Technical product information

Topic	New Continental GT Convertible – Front seat belt webbing twisted
Market area	Worldwide Bentley (1WBE)
Brand	Bentley
Transaction No.	2038562/1
Level	EH
Status	Approval
Release date

Front seat belt webbing twisted

Figure 3

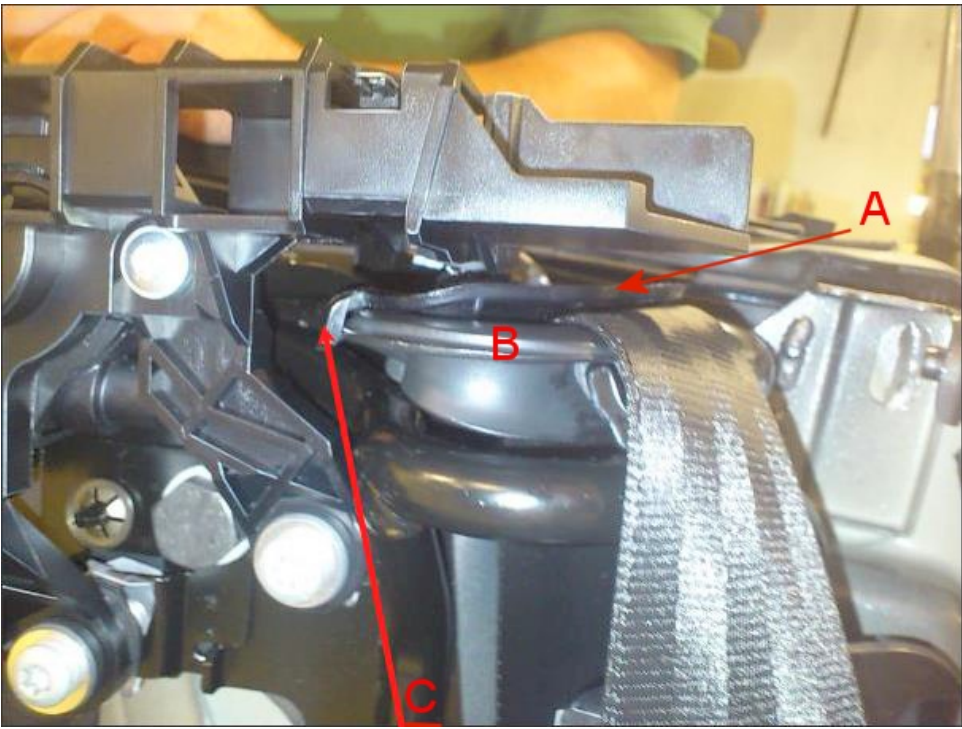
The plastic seat belt webbing guide, a plastic moulding incorporated in the seat belt upper 'D' loop assembly, may not have been fully clipped onto the metal 'D' loop. When this is the case a twist in the seat belt webbing is possible

Assembly method revised

2. Referencing figure 3 and 4 inspect the seat belt webbing plastic guide (A). Ensure the three clipping points (C) are securely clipped to the 'D' ring (B).
3. If the guide is not securely clipped then remove and discard the guide and fit a new replacement guide.
4. On completion the guide must be correctly secured to the 'D' ring paying close attention to both outer clipping features (C)
